Max Sweater (BD) Ltd (Extension)

22 May 2023

Observation

Structural design reports not available

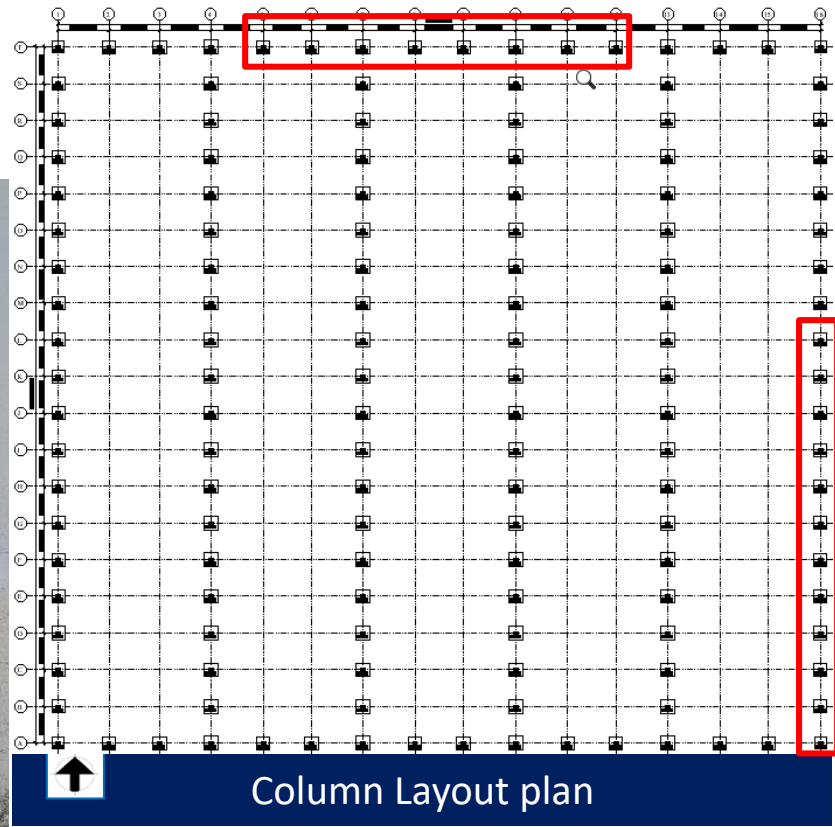
As per BNBC, building or structure shall have its design documents prepared in accordance with the provision of Section 1.9.1. The design document shall include a design report and a set of structural drawings which shall be prepared in compliance with section 1.9.1.1 and section 1.9.1.2 as per BNBC. The design report of the mentioned structures was not found which is required to be prepared in compliance with section 1.9.1.1 (part-6, BNBC).

Tie member missing in mid span

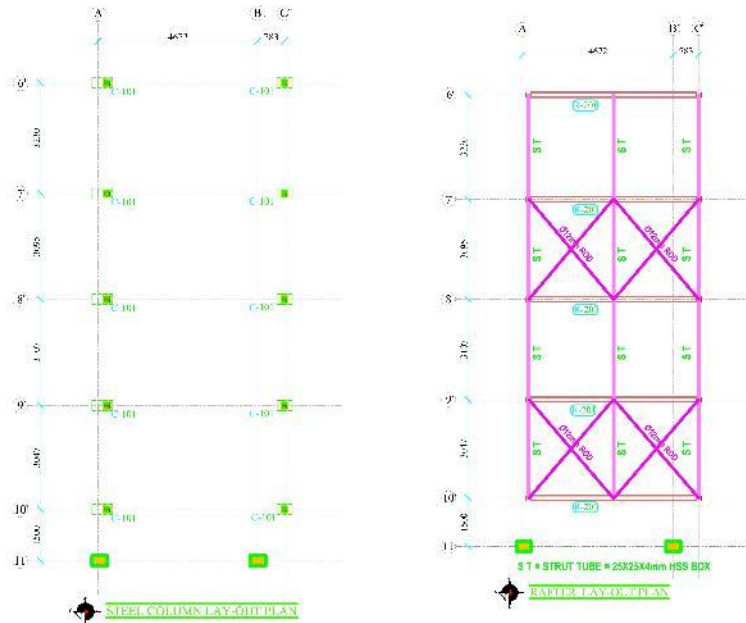
Truss tie in long direction L 50X50X6 is appeared to slender considering the length 3.66 m.

Lateral stability member in long direction appeared to be inadequate. Building engineer is required to check the lateral stability of the shed in long direction.

Column and truss layout plan

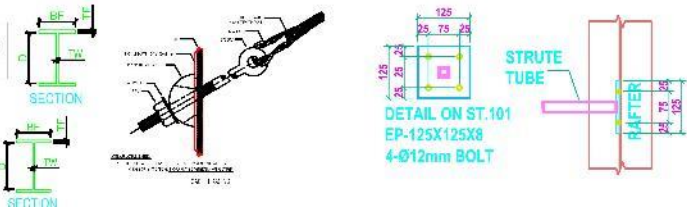
Compression strut

Compression strut of 25X25X4 mm size apparently inadequate for taking compression load. Building engineer is required to check the capacity of compression strut.

Non-engineered shed

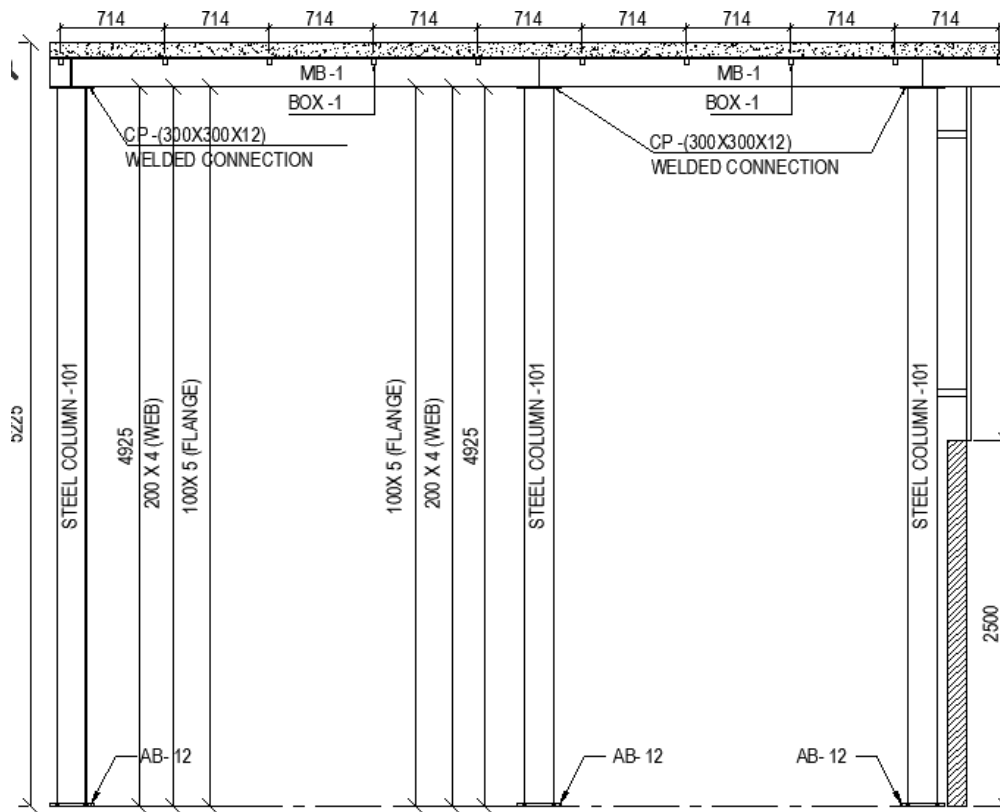
The shed has no other lateral stability system rather than 125 mm peripheral brick walls. Horizontal crack in the brick wall was observed which makes the wall unstable to resist lateral loads. The building engineer is required to check the lateral stability of the structure and suggest proper alternatives.
